# Knittex Industries Limited (Extension)

Plot: 247-252, Baimile, Konabari, Gazipur

1 January 2025

## 2. Observation

**Observation 7:** Corrosion on steel members (Connecting bridge).

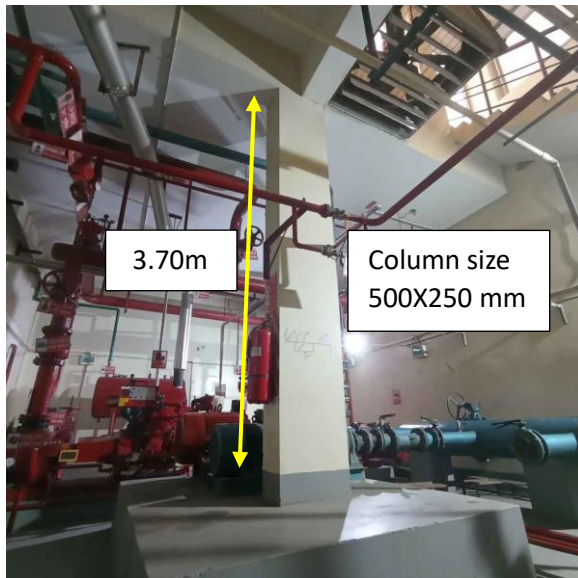
**Description:** Corrosion was observed on steel members at the connecting bridge. The building engineer is required to provide rust-proof paint on steel members.
